PUBLIC NOTICE
WOODLAND PARK PLANNING COMMISSION
Thursday, October 12, 2023, 6:30 P.M.
Council Chambers – 220 W. South Avenue

Planning Commission Staff Report Public Hearing October 12, 2023

Vacation: A request by applicant Derek Lutz (Farnsworth Group) and HSC Woodland Park, LLC (Property Owner) to consider a Conditional Use Permit and Site Plan Review, as well as a request to vacate the portion of Midland Avenue between Highway 67 and Burdette Street, for a proposed tire center store. The subject property is located at the NW corner of Midland Avenue and Highway 67 with a legal description of Lot 2, L. Clifford Filing No. 2, Woodland Park, Colorado and is zoned Service Commercial (SC). (QJ)

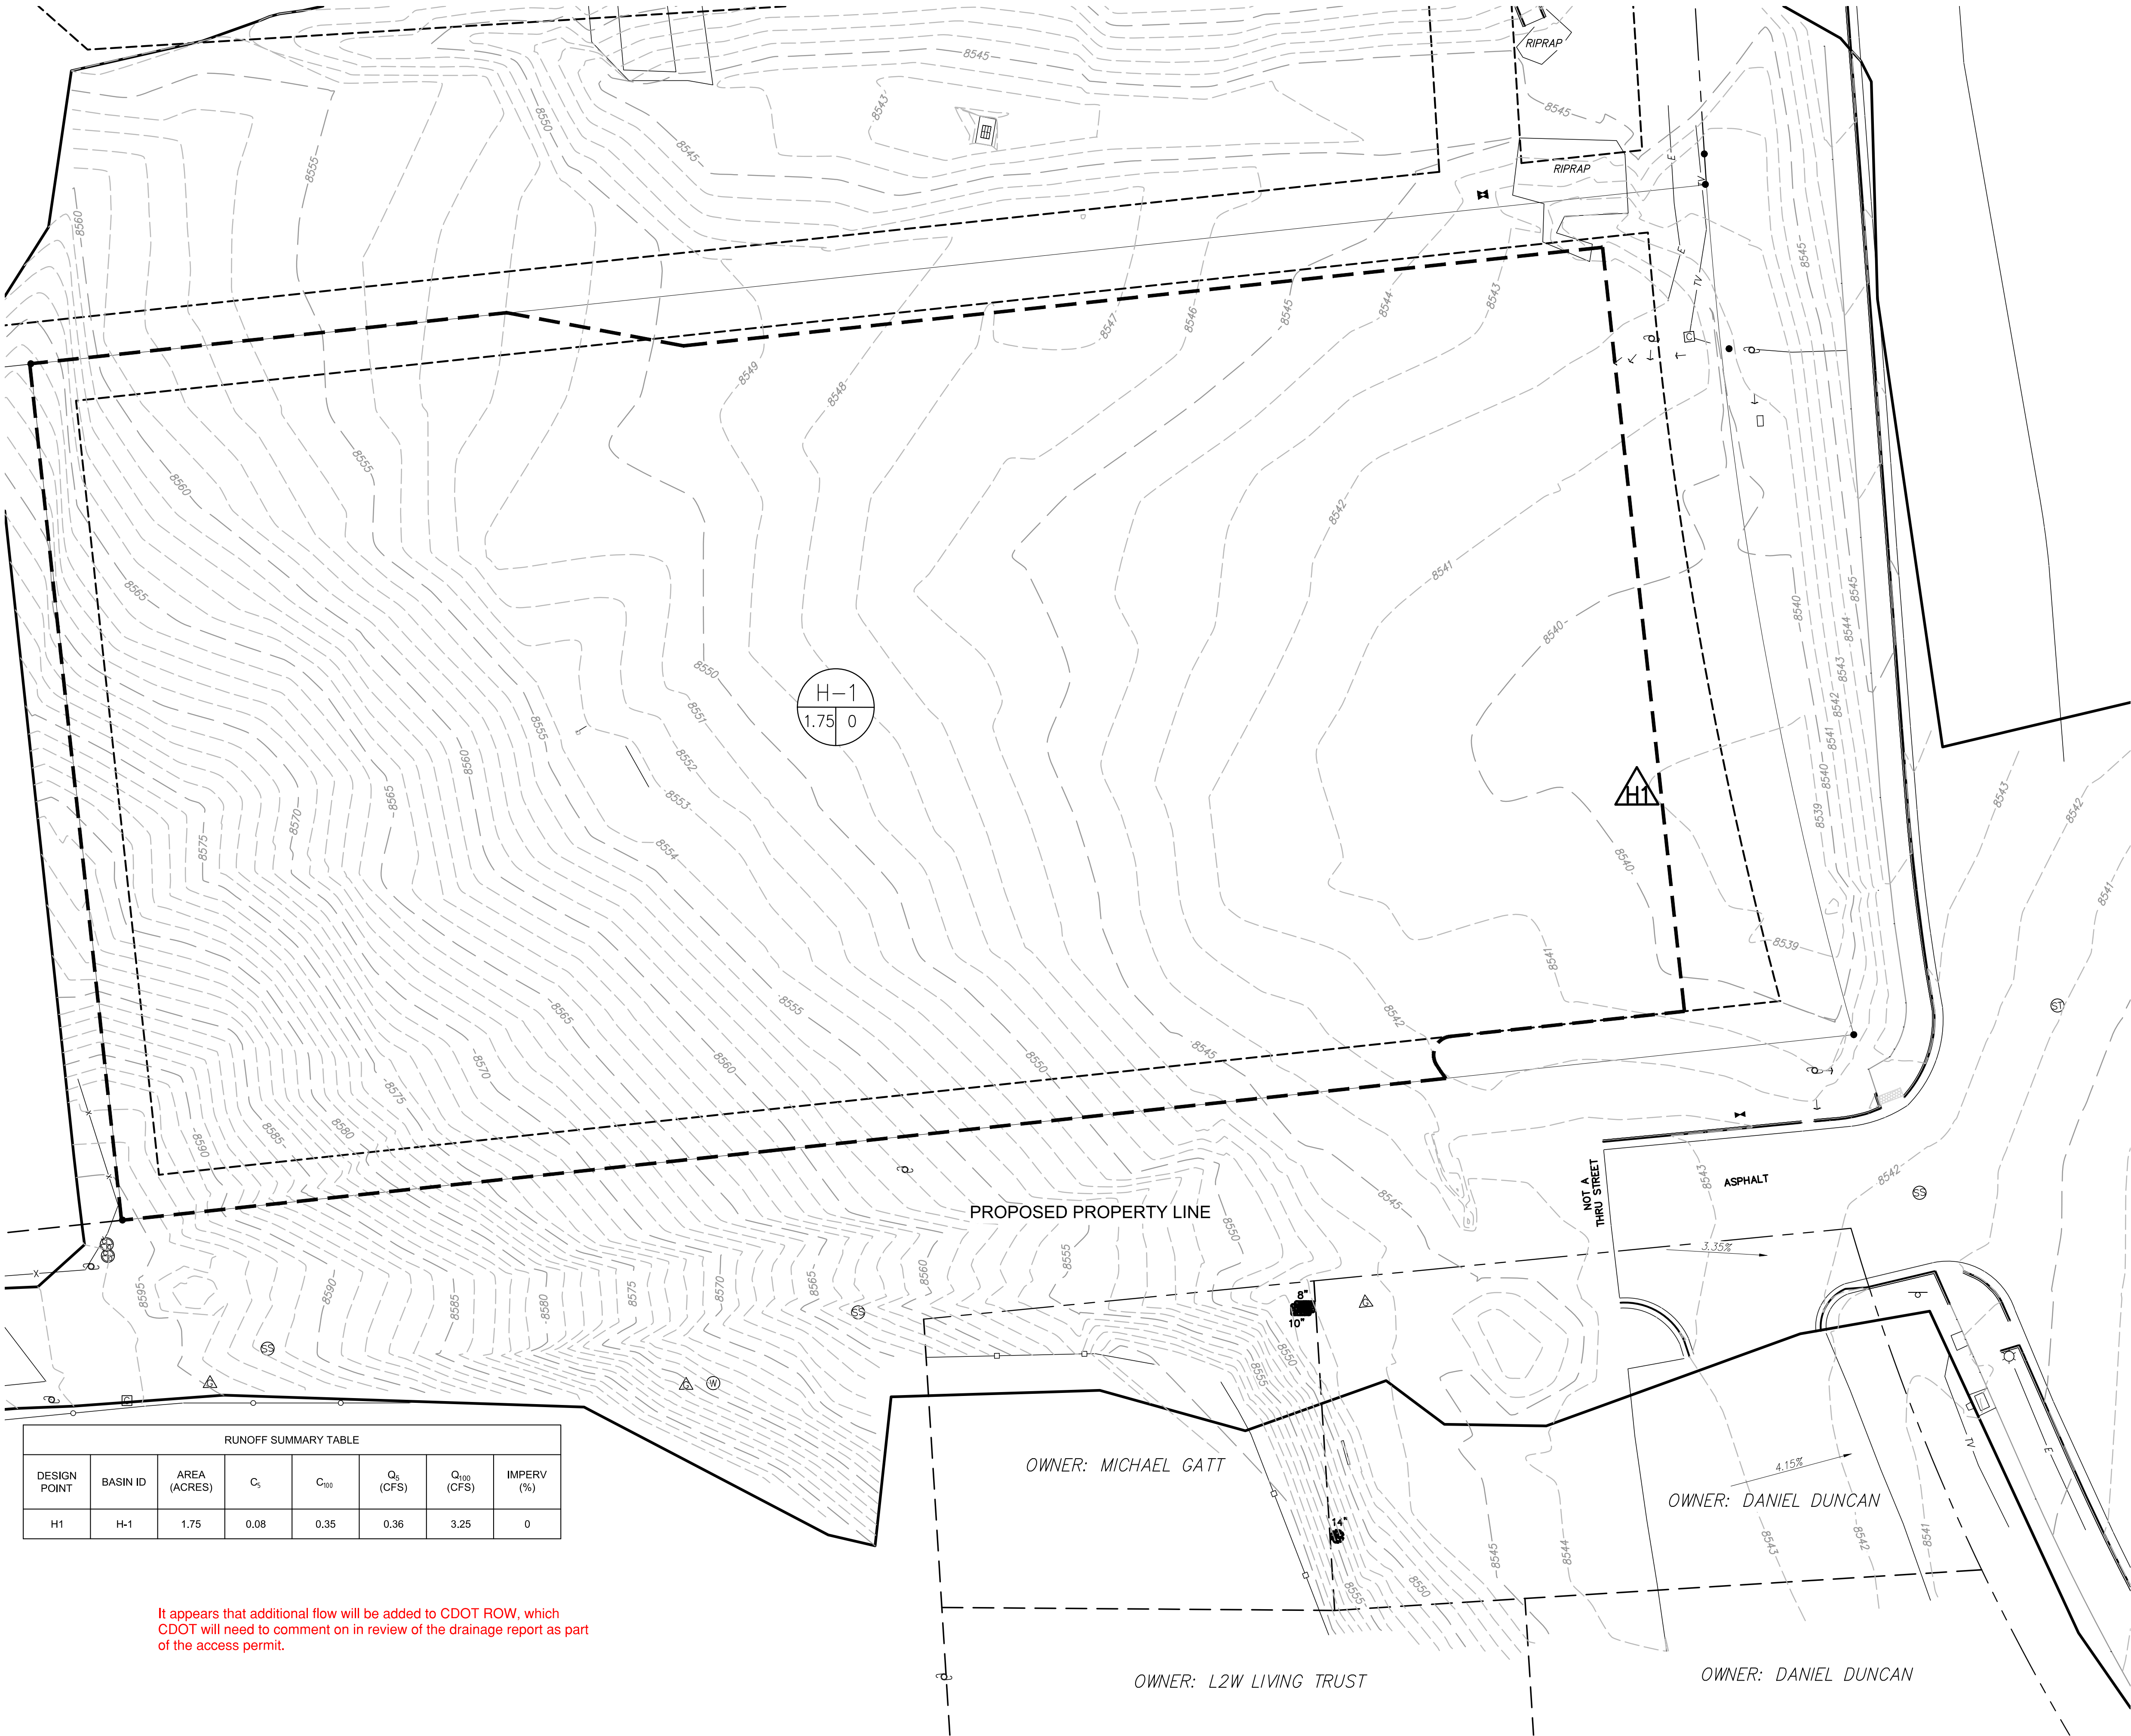
It appears that additional flow will be added to CDOT ROW, which CDOT will need to comment on in review of the drainage report as part of the access permit.

SITE PHOTOMETRIC
PLAN

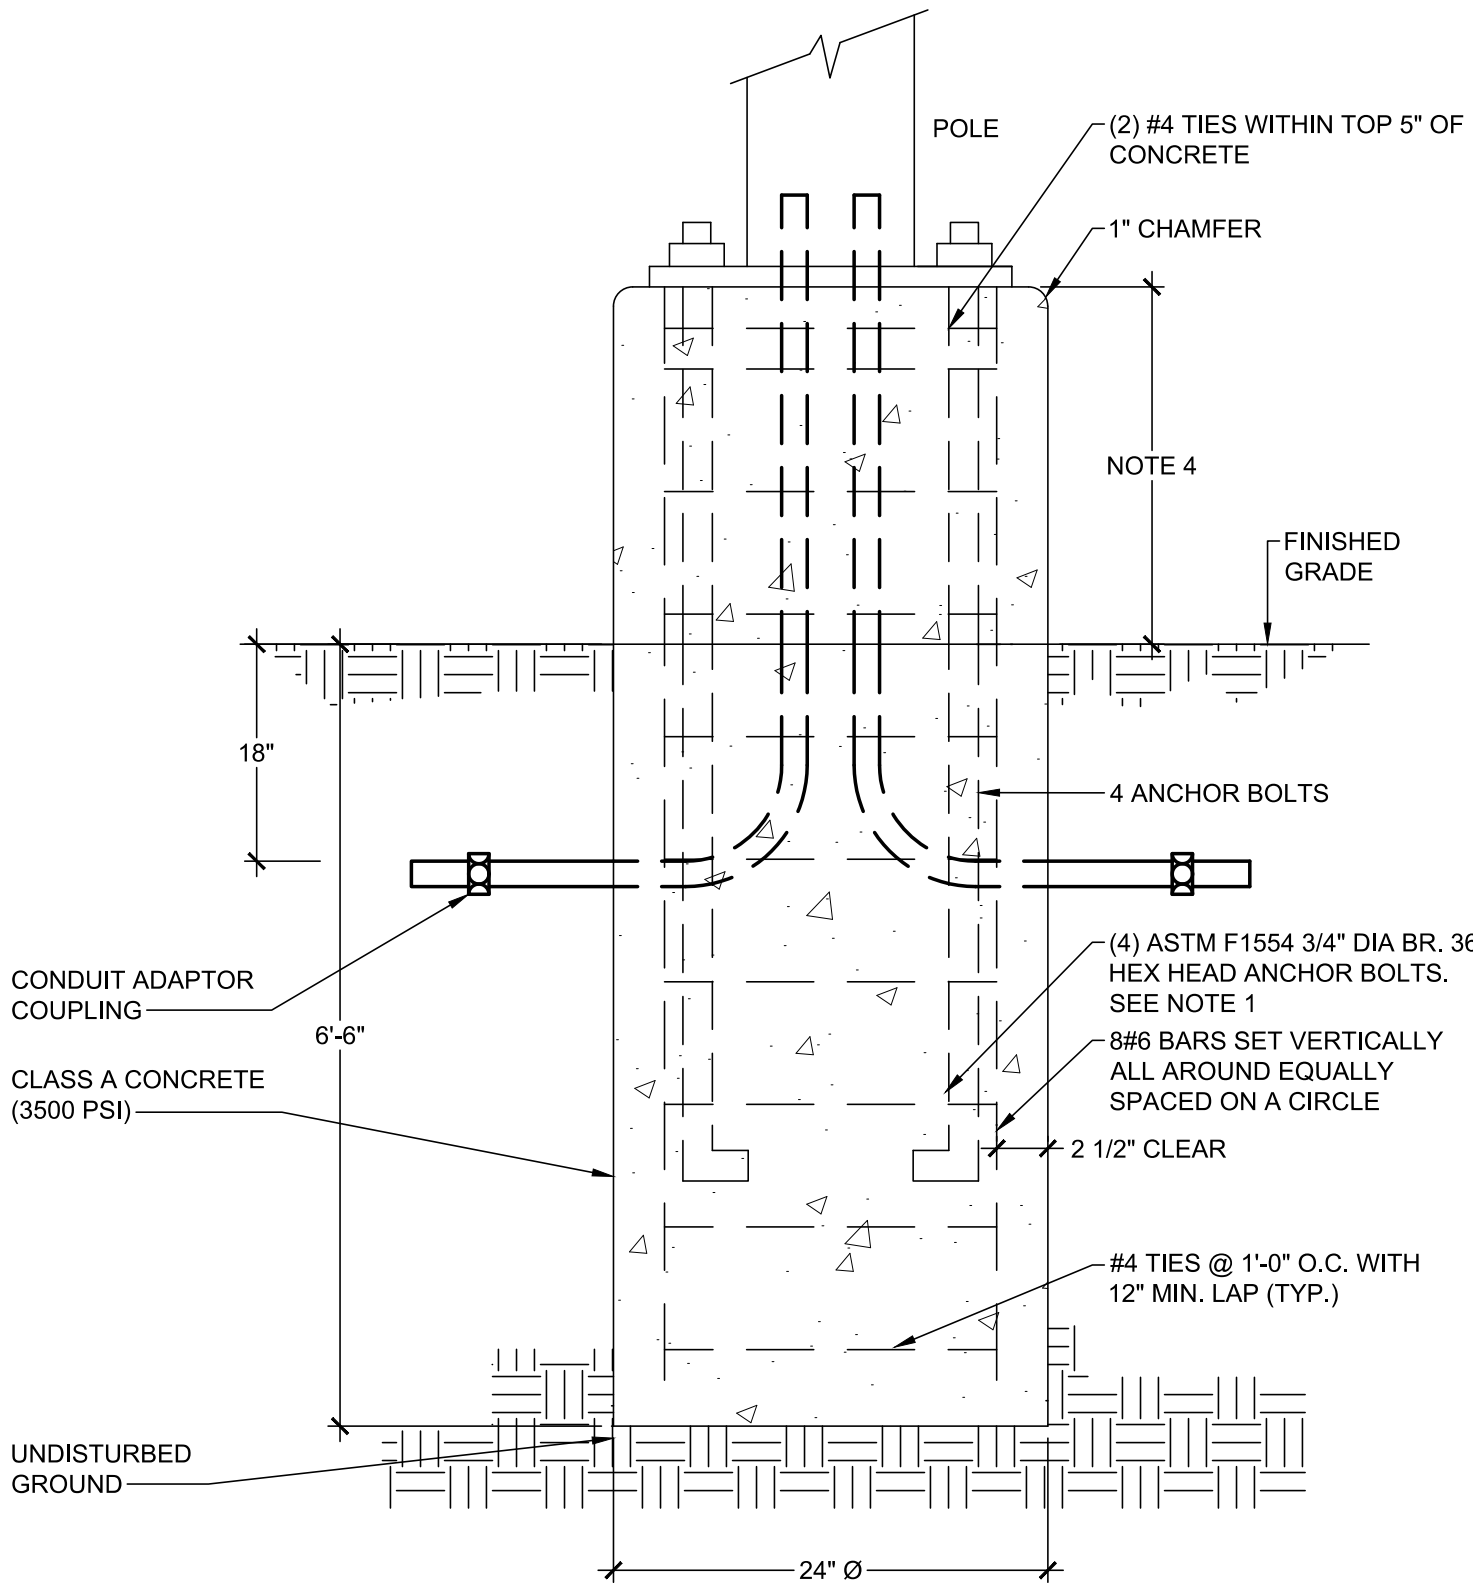
Is this the total height
of the mounted
lighting?

1 UTILITY PLAN
SCALE: 1"=20'

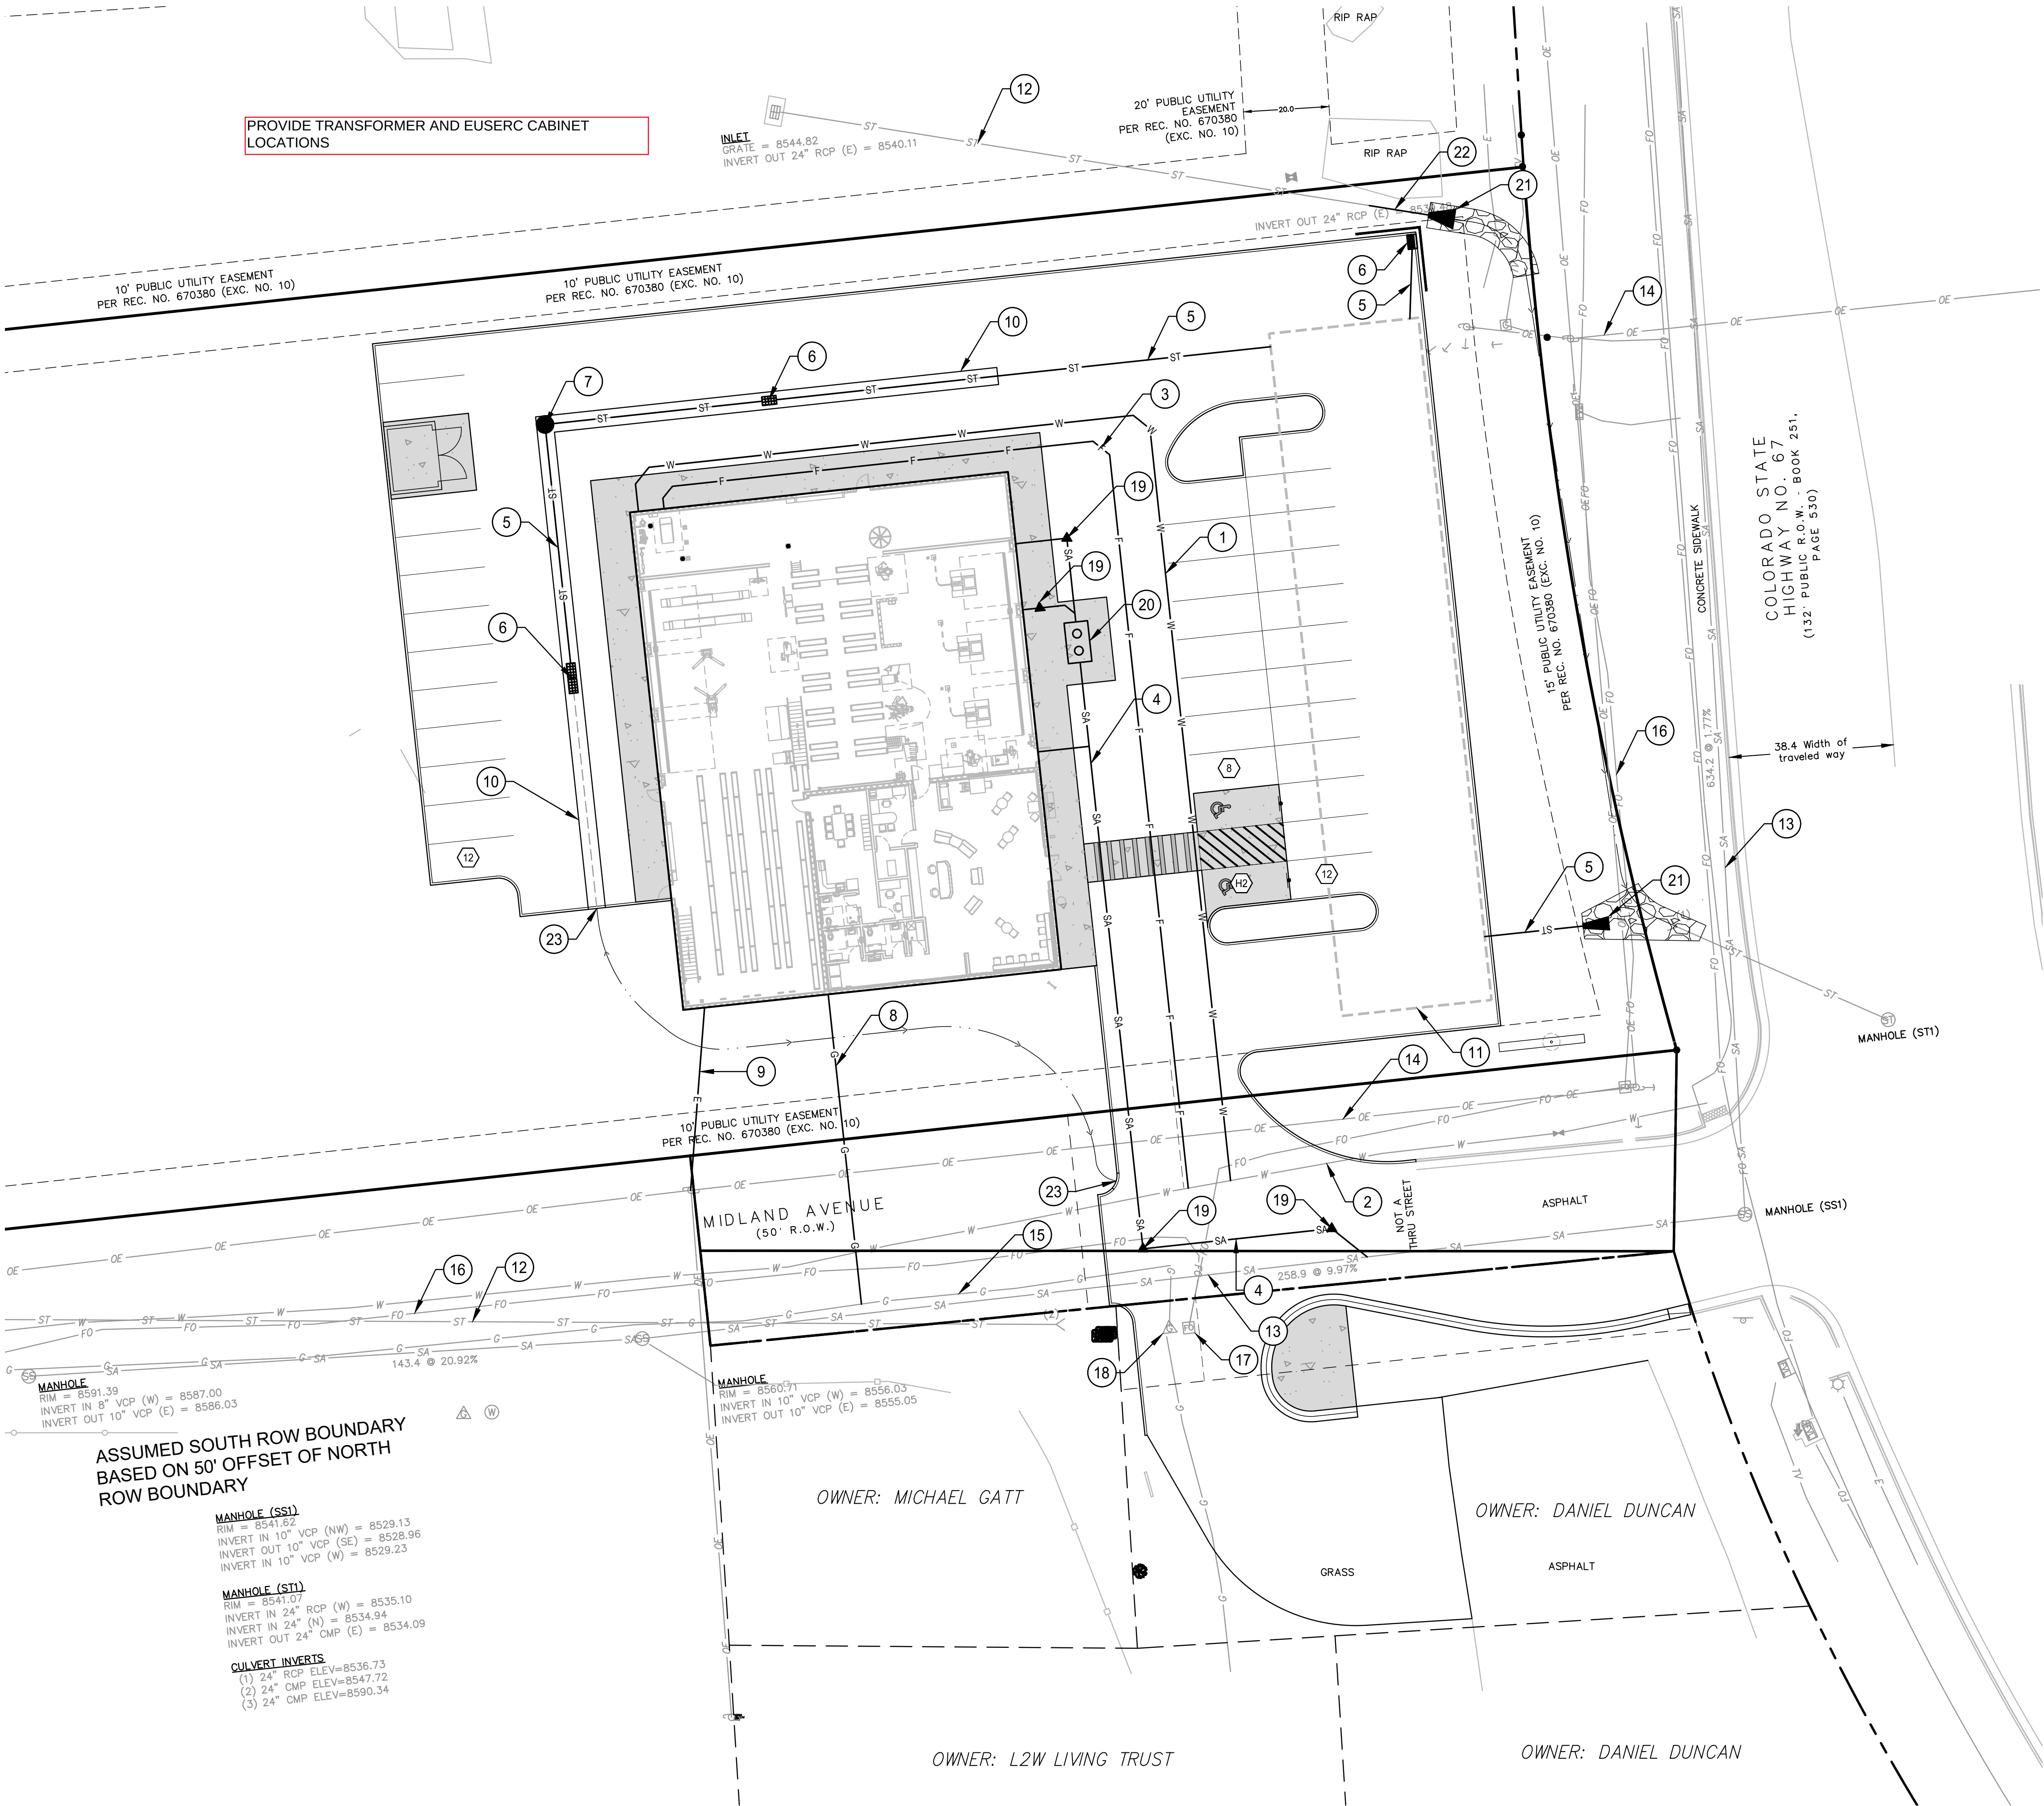
PROVIDE TRANSFORMER AND EUSERC CABINET LOCATIONS
